UNITED STATES PATENT AND TRADEMARK OFFICE

APPLICATION NO.	FILING DATE	FIRST NAMED INVENTOR	ATTORNEY DOCKET NO.	CONFIRMATION NO.
09/921,609	08/03/2001	Bret D. Cannon	50005-19	7493

Office Action Summary	Application No. 09/921,609	Applicant(s) CANNON ET AL.	
	Examiner Richard A Rosenberger	Art Unit 2877

One slide, on page 7 of the document, shows

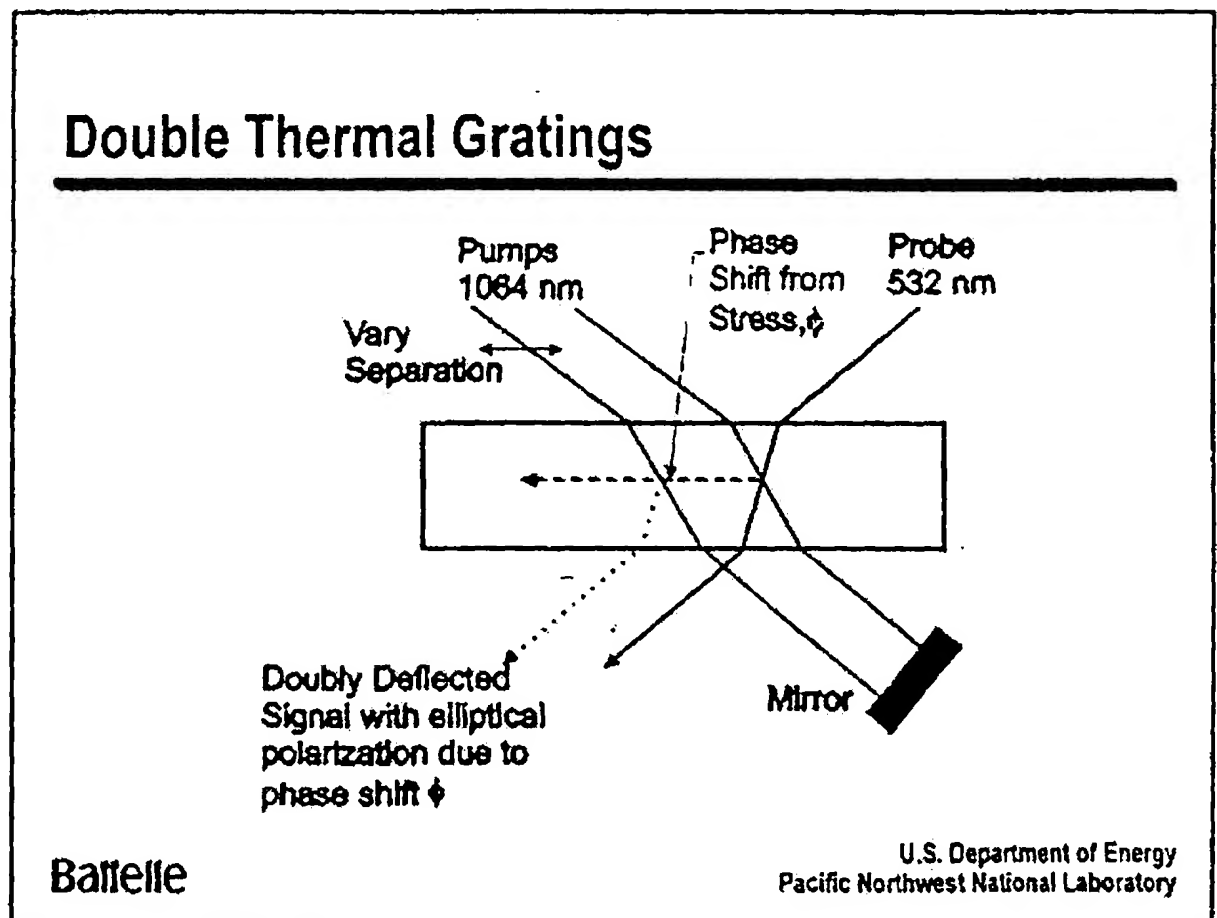
3. Claims 1-73 are rejected under 35 U.S.C. 103(a) as being unpatentable over the document cited on the form 1149 filed 3 August 2001, identified as "slides from 'proceedings of the FY 1999 Glass Industry Project Review'"

The previous slide in that document identifies the sample as "tempered automotive glass", and notes that the technique was used for obtaining "measured in-plane stress."

The first slide on page 6, showing a related thermal grating system, notes that the pump beams and retroreflecting mirror will create standing waves which in turn create the thermal gratings, and notes that the beams is “diffracted parallel to the faces of the glass plate”.

The pump beams are shown in the slide above as having a wavelength of exactly twice the probe beam (1064 nm vs. 532 nm.); one known and obvious manner of obtaining this relationship is to generate one frequency from the other from a single source by known frequency doubling techniques or the like.

The slide shown above notes that the doubly deflected signal has “elliptical polarization due to phase shift ϕ ”, this at least clearly suggests “detecting the polarization state of the exiting doubly deflected beam.”

As the slide above shows the deflected beam being deflected within the glass sheet, it would have been obvious to have that beam substantially smaller than the thickness of the glass plate in order to maintain a “clean” intermediate beam by avoiding possible edge effects of the thermal grating near the surfaces of the glass plate and without interference effects in the deflected beam arising from reflections by a edges of a wider beam from the surfaces of the plate.

It would have been obvious to configure the width of the three beams shown in the slide above to match their respective purposes of creating the thermal gratings for the pump beams and for diffracting “cleanly” for the probe beam. There would be no reason for those in the art to assume that identical sized beams would

serve the different purposes equally well, and no more than routine experimentation would be needed to find appropriate sizes for the different beams.

The slide above shows varying the separation of the two pump beams. Using a motorized mechanism for this would have been obvious.
